Mynydd Maen Action Group

Report on RPS Document “Cil Lolydd Solar Farm Phase 1 Peat Probing”

(RPS document dated 13th March 2025)

Below is Figure 1, from the RPS probing report, to which we have added the position numbers (P045-P072) of the coordinates that we were interested in, that is, those on the common. Point 066 appears to be missing from RPS' peat report.

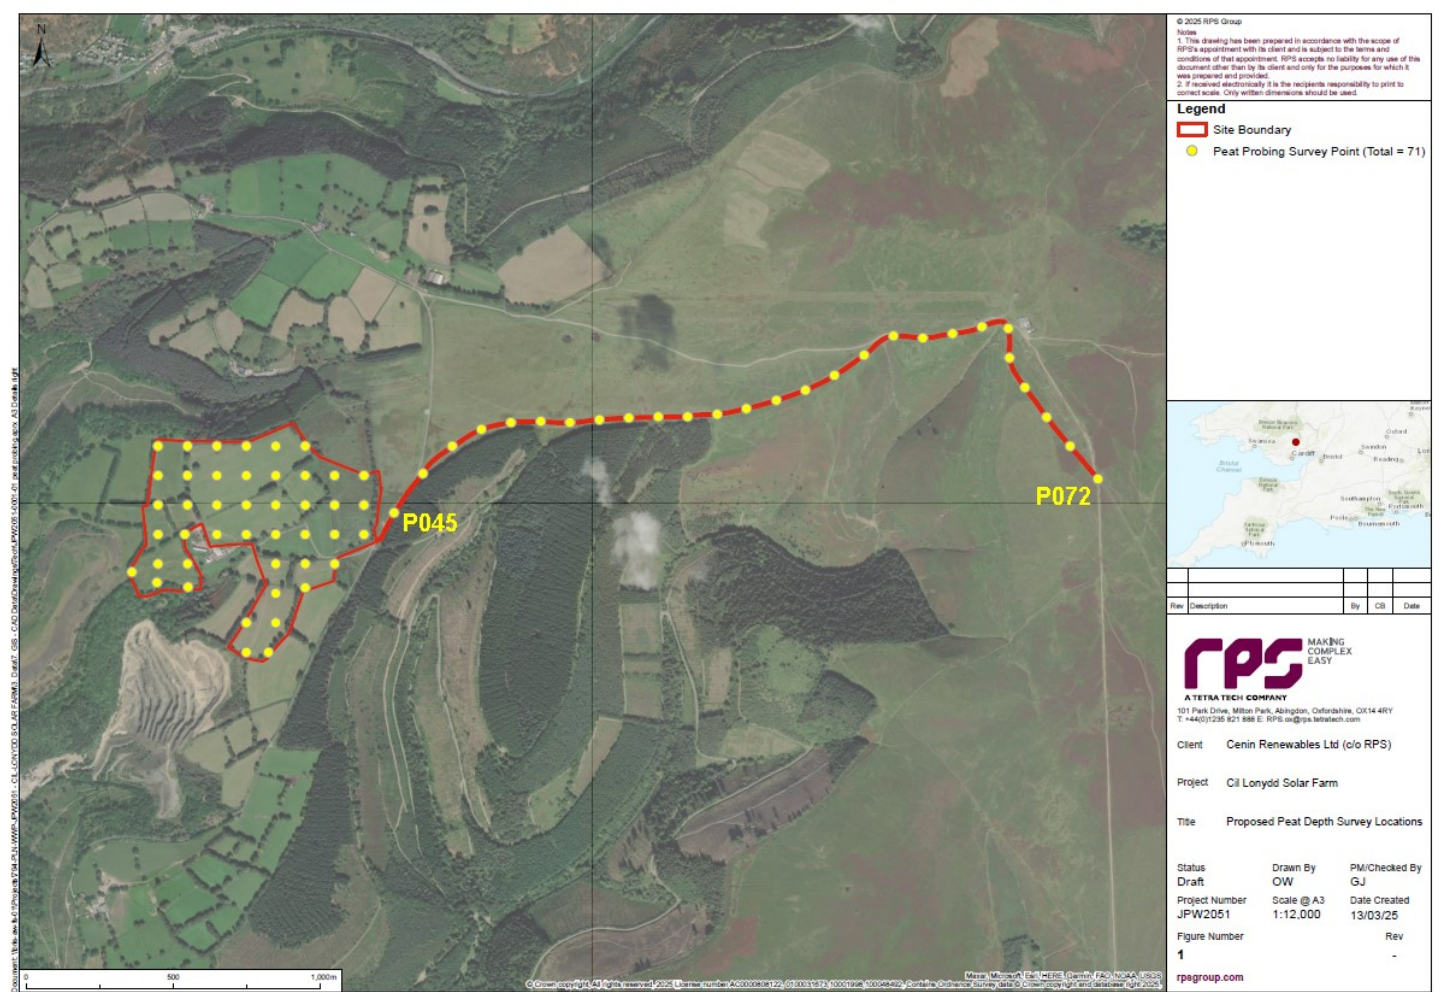
Furthermore from P067 to P072 it appears that they followed the obvious route, along the gravel road, rather than the route that is set out by the given coordinates and as indicated by their map (Figure 1 above). The route indicated on the map and by the coordinates follows a PRoW marked in the OS map which is neither used nor visible on the ground.

Here is an extract from our results spreadsheet

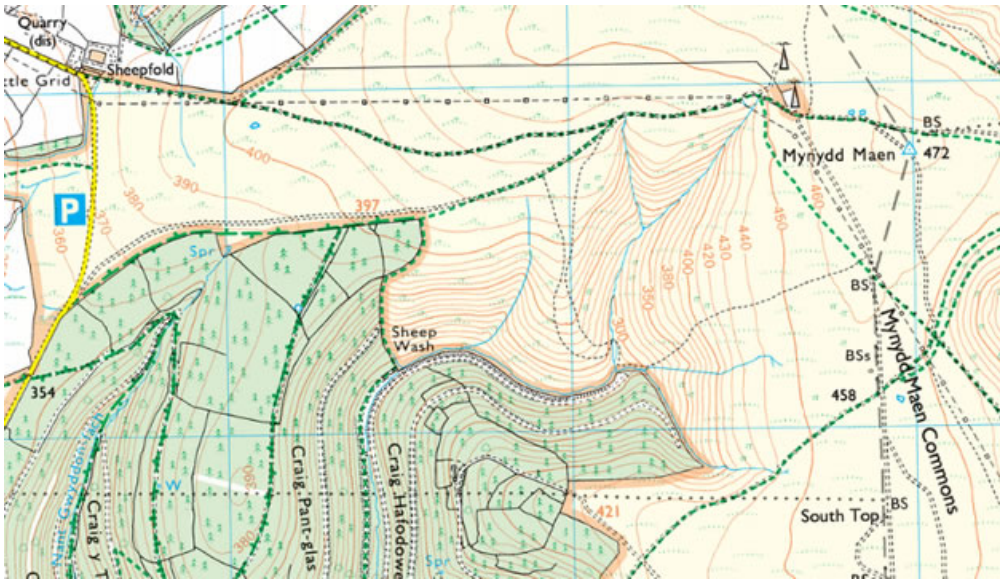
- 1 Not a good start! Accurate position was on the east side of the road, not in road, and the road was tarmac, not concrete.
- 2 Totally different results for RPS survey and our survey, in most cases we measured on the point and a few metres left and then right, looking west
- 3 Choice of survey position strange, lots of damaged land to north of positions, why not use that to dig the cable trench?
- 4 Such differing results that we were obviously in totally different places!

Note that our results differed from those recorded by RPS on all but a few locations.

OS Map

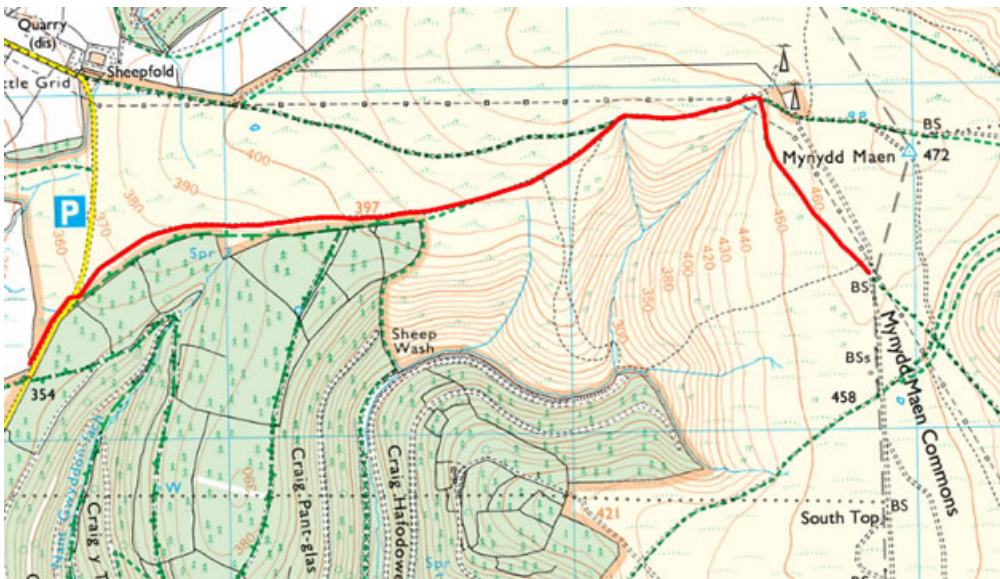
On this map the PROWs, in green, which sometimes follow the tracks, are more prominent than the tracks without the green dashed footpath lines.

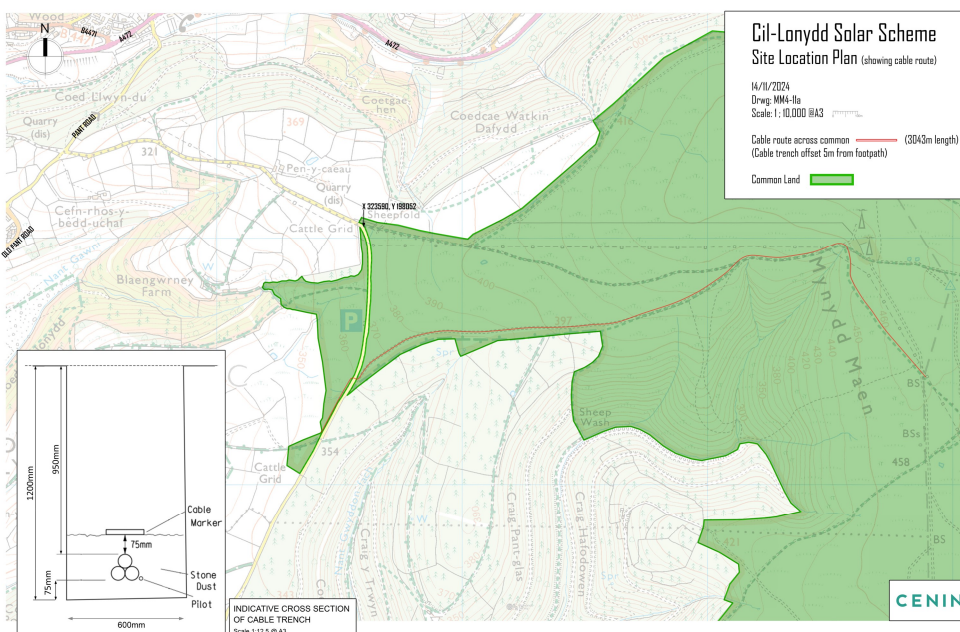
Our belief is that the person planning this cable run did not survey the site, they just traced the obvious green line on the OS map, as we have done on the left.

This is exactly how it ended up! If the applicant had actually visited site they would have realised that, after the gas station, they were following a non existent path.

Furthermore, the cable route extends well beyond the RES substation, when examined on the ground.

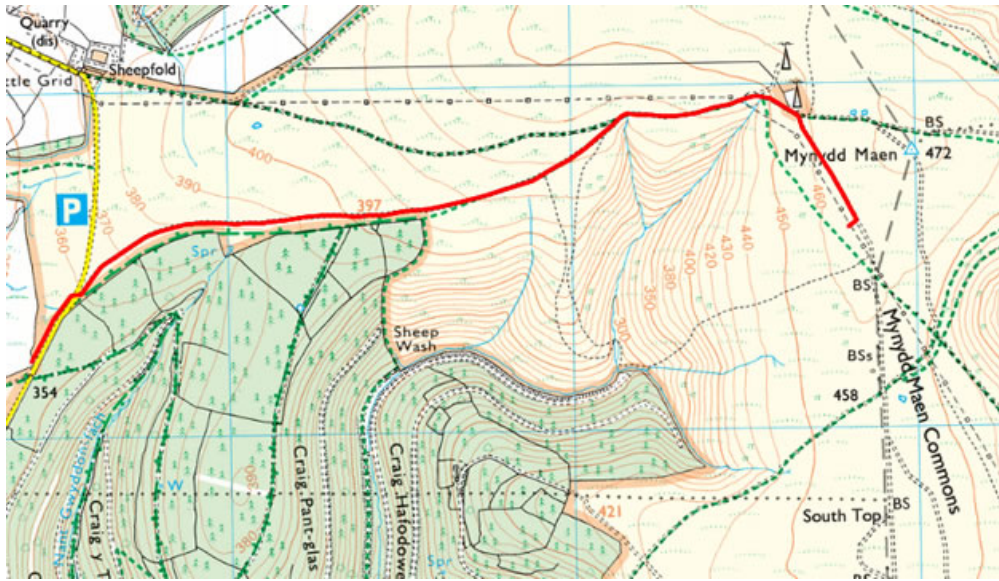
An in-person site visit would have resulted in a far more practicable cable route such as we suggest below. This route follows the gravel track south from the gas station and the mast.

We suspect this last section must be the route that the peat surveyor followed, seemingly without the benefit of any GPS location.

In our view, a far less damaging cable route could have been planned by actually surveying the proposed route and choosing to design the cable trench to follow the existing tracks and ruts, generally avoiding peat, and actually following the gravel roads where they exist.
